# Coastal Works Review

**East End – Construction of a Groyne and Excavation of Swim Areas  
Block: 73A Parcel: 80**

**PREPARED FOR: MINISTRY OF HEALTH, ENVIRONMENT, CULTURE AND HOUSING**

April 30, 2020

FIGURE 6: SITE VISIT PHOTOS SHOWING THE USE OF SILT SCREENS AT THE WYNDHAM REEF RESORT AND ELSEWHERE WHERE THEY HAVE IMPACTED SEAGRASS BEDS (SOURCE: DOE 2019)

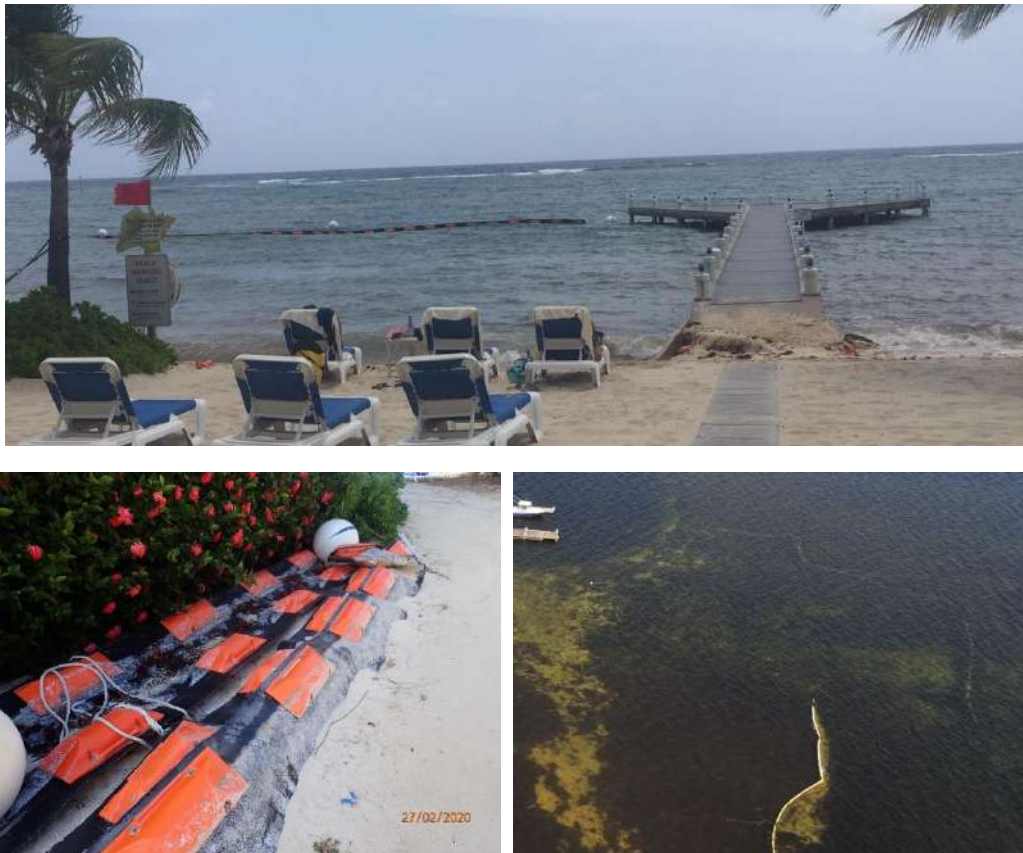
The application documents also include mention of the proposed future use of 50-100ft of sargassum containment booms to be attached to the end of the groyne to aid in the deflection of sargassum along the coastline. These are to be secured in place using flat steel or concrete anchors. However the applicant has confirmed that this proposal is not a part of this application and will require separate minor coastal works approval as with any structure placed on or over the Crown owned seabed. The application information also states that the screens 'will have no effect on the immediate environment' however the DOE is aware of booms used in other areas that have caused direct impacts to seagrass beds; the anchoring system for the booms will also create areas of impact. The DOE previously advised the applicants that the booms required Coastal Works approval to be installed as they were deployed without permission (see figure 6 below) but have since been removed.

Figure 1. Site Location Plan showing the proposed groyne (outlined in orange) (LIS, 2018 and DOE, 2020).

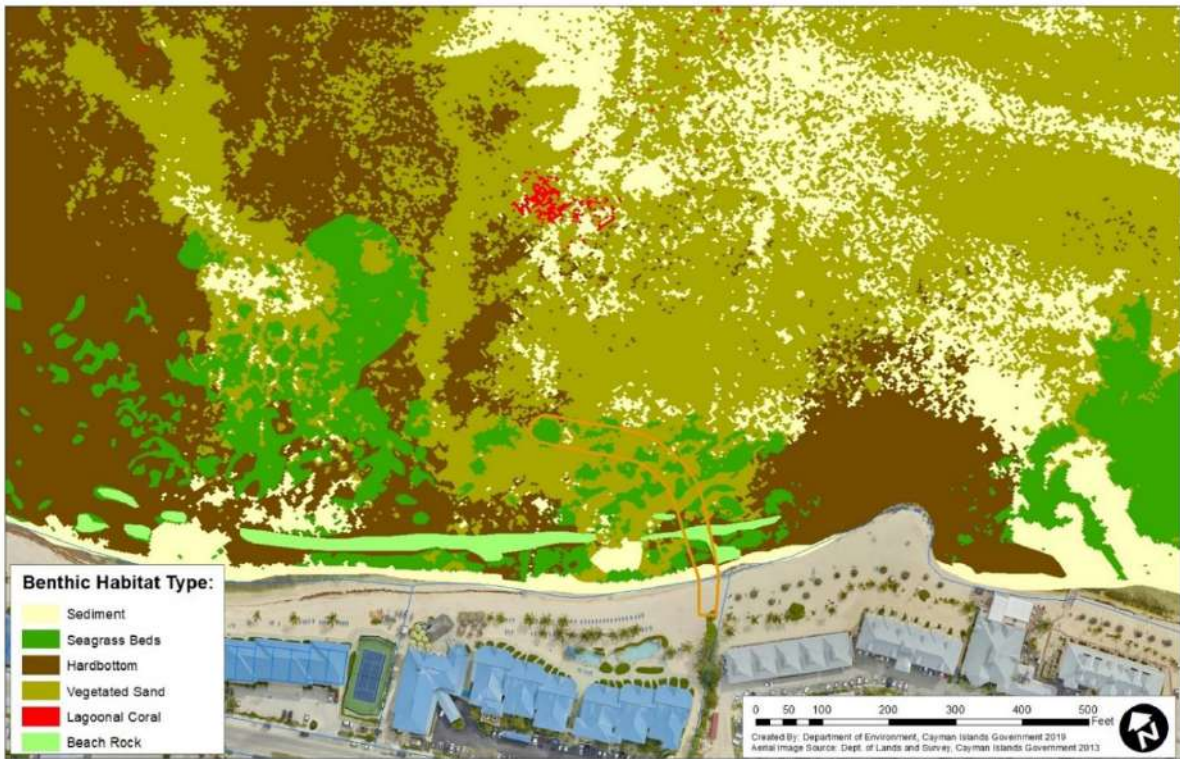
The proposed development comprises a stone groyne which will measure approximately 400ft long forming a curved shape and 42ft wide, as shown in figure 1 and appendix A below. The height of the groyne emerging from the water at spring tide level is proposed to be 18inches. The groyne is to be formed of a core of base stone capped with larger stone boulders (2ft+ in diameter) placed on top of a geotextile membrane over the existing seabed grade of -0 to -5ft deep below mean sea level. The purpose of the groyne is to provide protection for the beach and a swimming area from Sargassum influxes to a swimming area in front of the existing Wyndham Beach Resort. The protected swimming area would be to the immediate west of the groyne, within its curvature, and would include the existing 150ft long dock in front of the main resort building.

The seabed in the footprint of the proposed groyne contains seagrass beds, vegetated sand (containing algae) hard bottom seabed, and emergent beach rock (as shown on figure 2 below). The placement of the groyne over these seabed habitats will displace them resulting in the loss of their ecosystem services and habitat functions. Seagrass in particular is an important feature and contributor to the health of the marine ecosystem by providing living habitat, food and oxygen to marine fauna. Seagrass also plays a vital role in maintaining good water quality and providing some coastal buffering to mitigate the erosional effects of wave energy. If Cabinet is minded to approve this application the DOE would recommend the charging of an Environmental Mitigation fee based on the area of impact.
